Baldwin County Commission  
Special Work Session Minutes

**REVIEW AND DISCUSSION OF WRITTEN PUBLIC INPUT REGARDING PROPOSED REVISIONS TO BALDWIN COUNTY SUBDIVISION REGULATIONS**

Jay Dickson, Planning Director, discussed the public comments received during the public comment period for the proposed revisions to the Baldwin County Subdivision Regulations. Mr. Dickson gave a presentation [Subdivision Regulation Amendments](#), which outlined the common comments received and a proposed resolution for each issue.

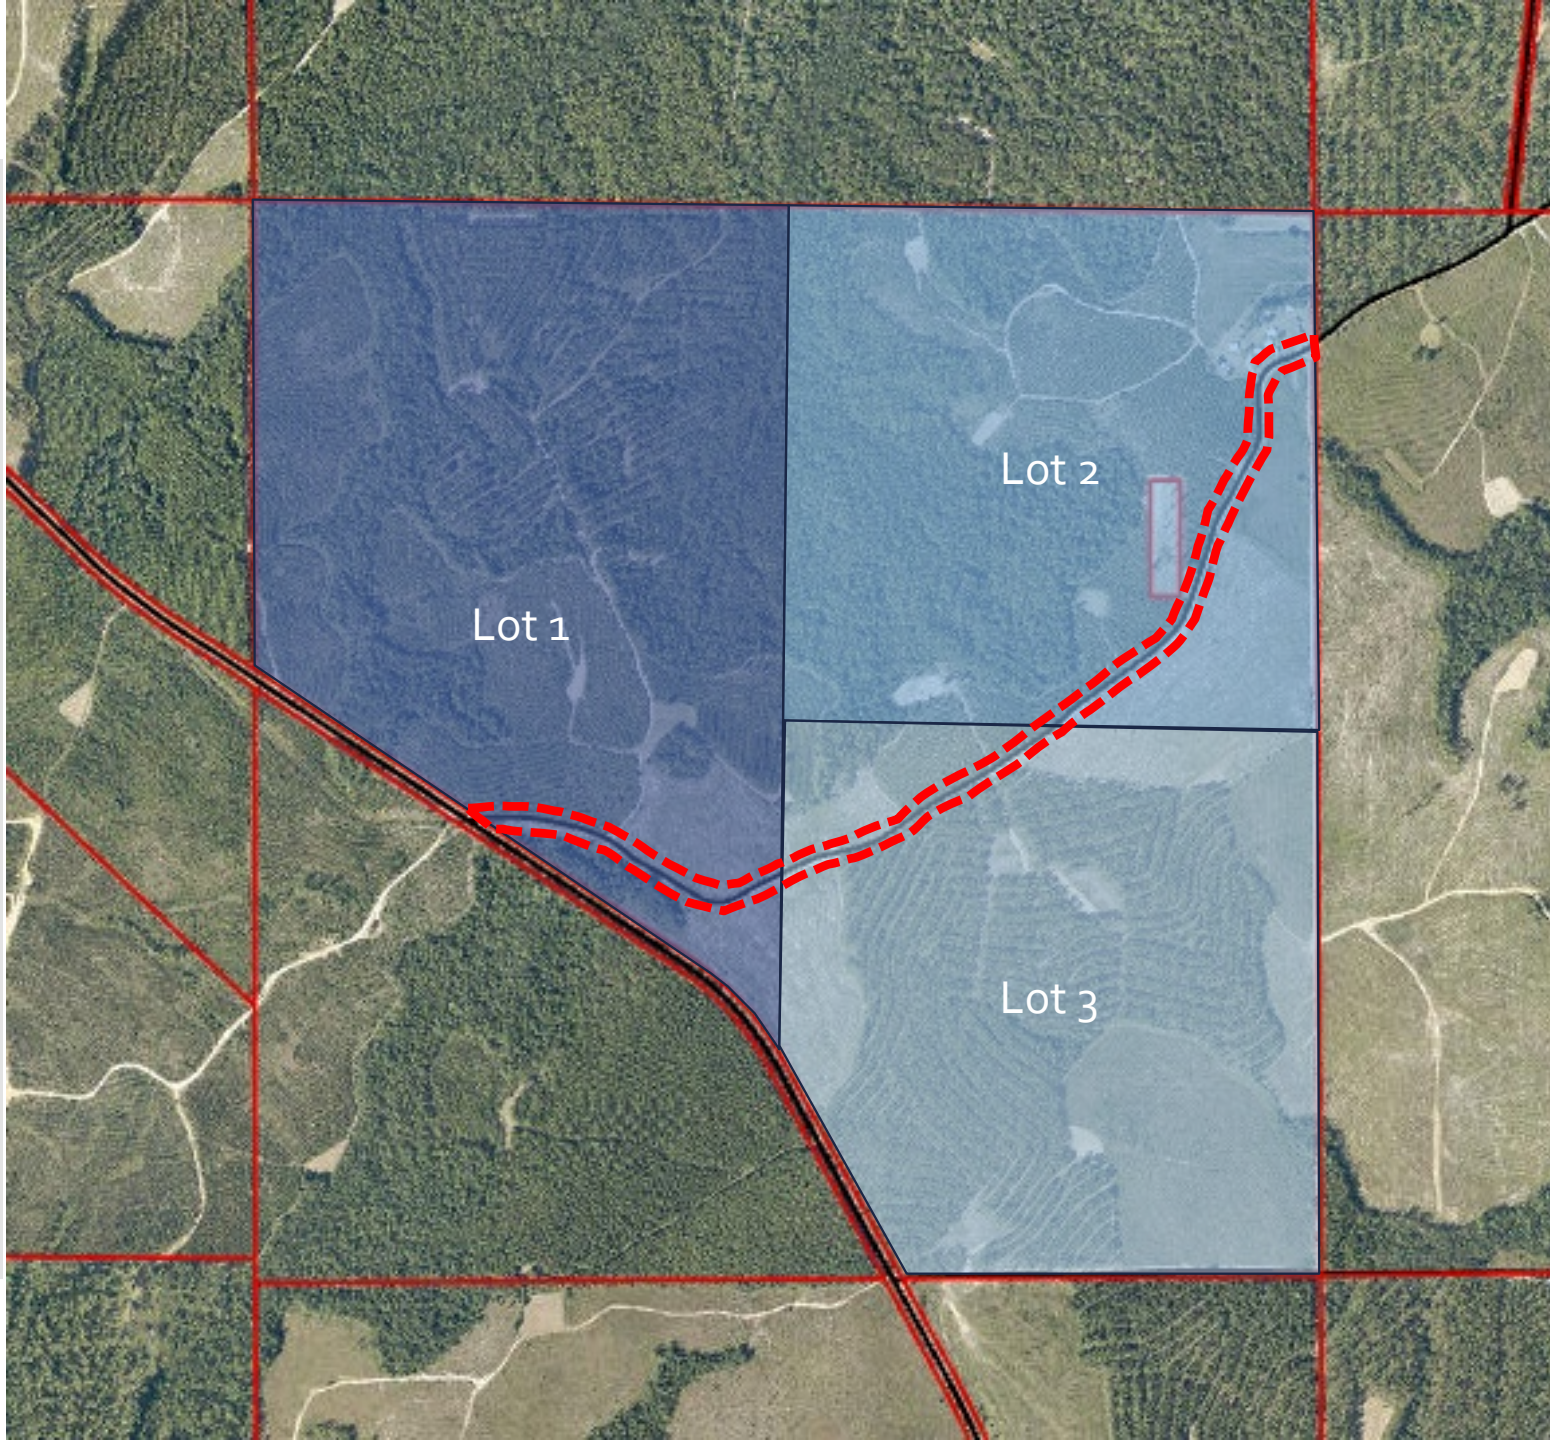
If the large acre lots front on the 60' wide easement and not bisect it, who will own the easement? Are you requiring a POA to be set up?

FIGURE 5.1

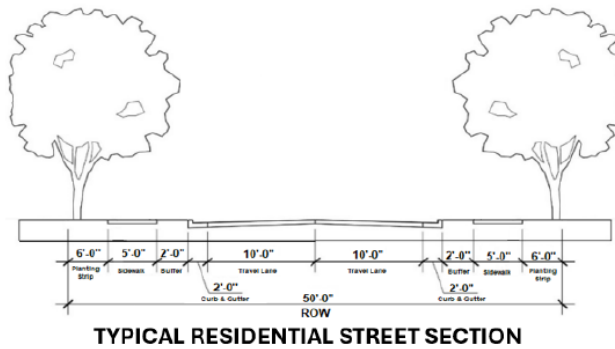
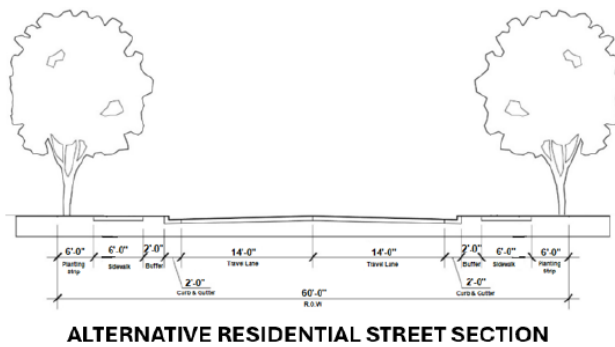
Provide utility corridors and consider allowing some utilities to be below the street and/or sidewalks. Add clarification for when the Alternative Street Section is to be used.

Agree. Will revise to allow street trees outside of the ROW but no further than 5 feet from ROW line. Alternative Street Section will be clarified to be required on streets where lots are between 60 feet and 80 feet in width.

#### 6.2.1 General Requirements

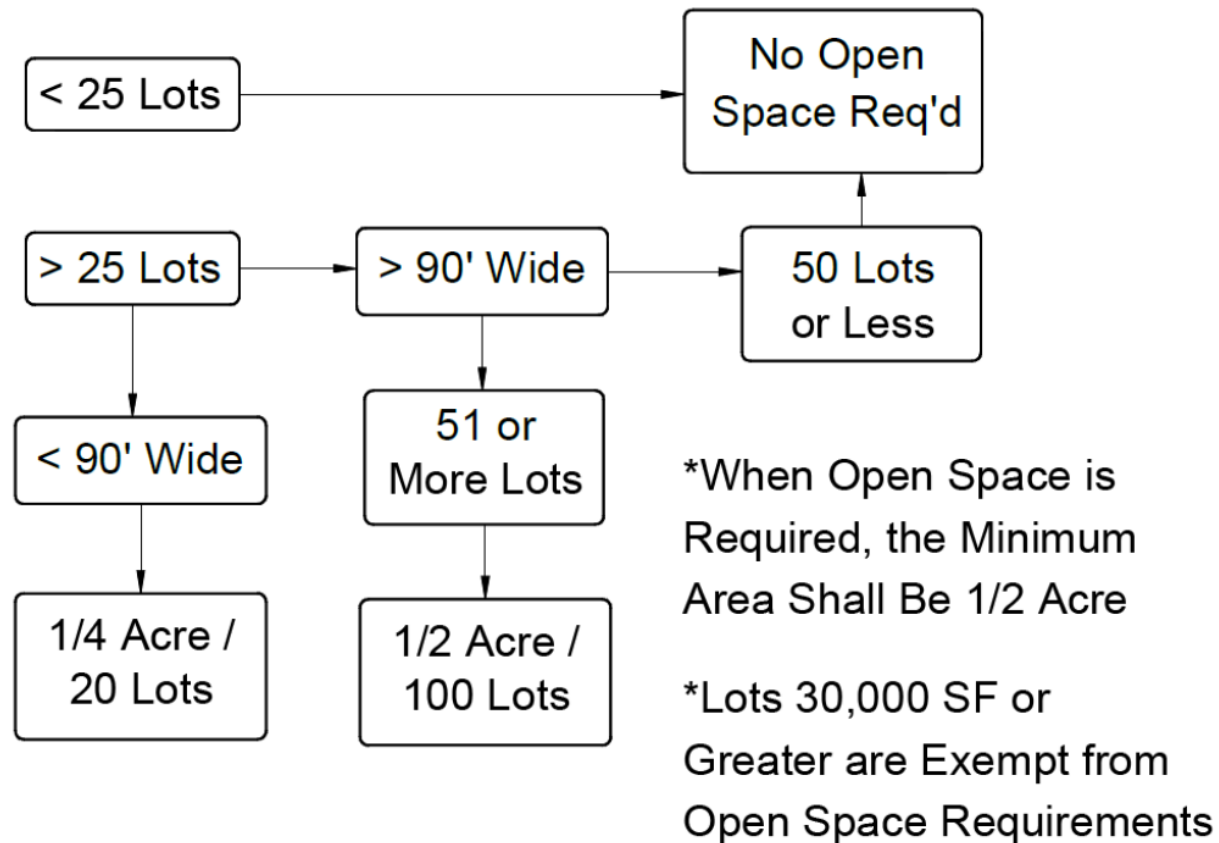
I do believe that Open Space is needed in developments once they have a certain number of lots, and especially when the lots are smaller with not much space in the yards. I have found that they encourage more density and smaller lots, in order to make up for the cost of land lost. We need a way to provide Open Space and encourage larger lots. My proposal is to base the Open Space on the number of units, as opposed to a flat percentage.

This is a common approach that would provide a mechanism to tie usable open space requirements to the context of the density being proposed. Would be better to categorize the lot sizes by square footage rather than width as area of open space is what is important so all measures should be by area rather than width. Proposed changes:

### 5.12.5(i) & (e) – Stormwater Management Construction Plan Requirements

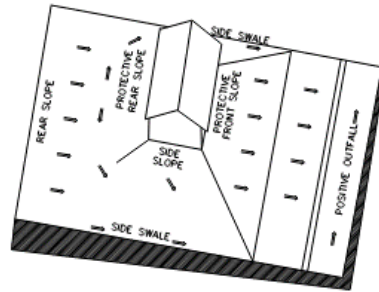
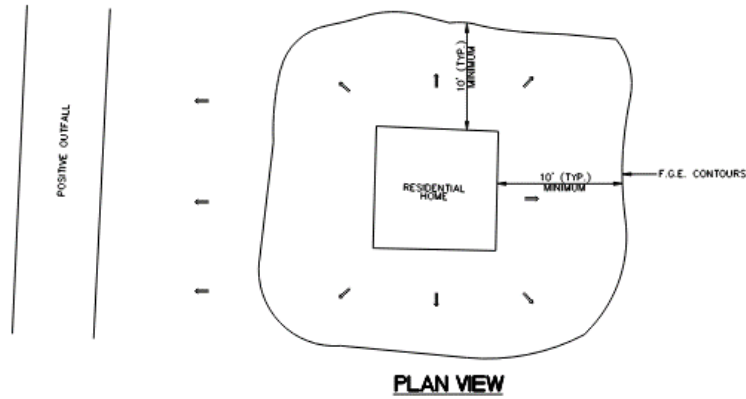
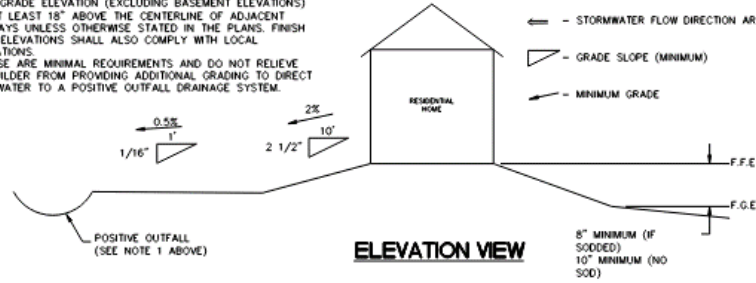
**Comment Received 5.12.5(e):** Change "cross section" to "typical section"

**Resolution:** Agree

Utility Requirements  
5.2.5(b) – Sanitary Sewer System

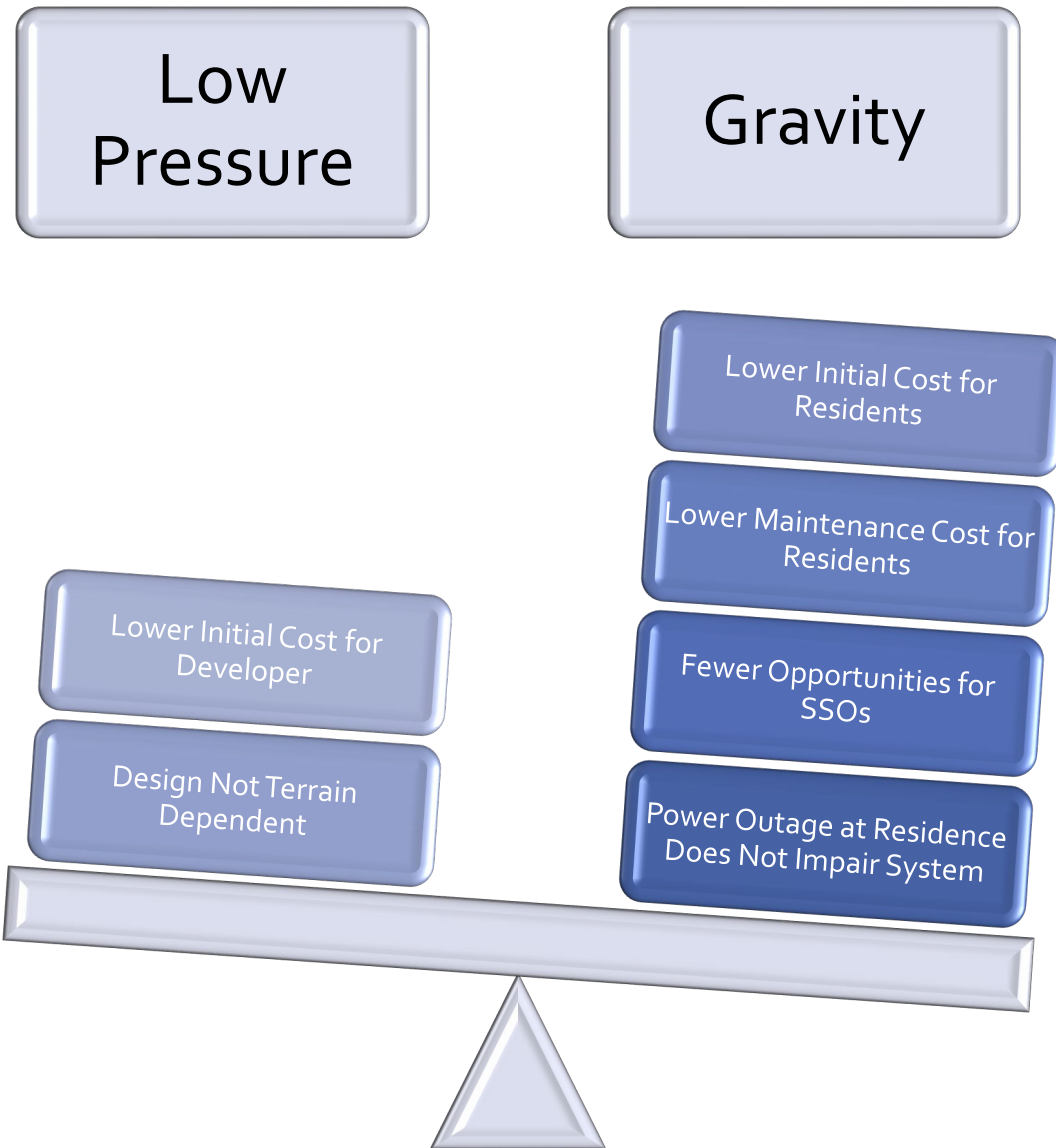
**Comment Received:** The proposed amendments to the subdivision regulations purport to limit the use of low-pressure sewer collection systems and the use of grinder pumps, which is a viable and proven system for the collection and transmission of wastewater for treatment along with gravity systems. In addition, in many areas that are subject to high levels of rain, wetland areas, and areas subject to flooding and/or significant surface drainage, gravity systems, which are open systems which utilize manholes and other components which are not completely enclosed, allow the inundation of stormwater into the wastewater collection system resulting in significant increases of water in the system, which can result in sewer overflows. The design of the system should be left to the utility provider (and the engineer of record) which will be ultimately responsible for its construction, operation, and maintenance in accordance with ADEM requirements.
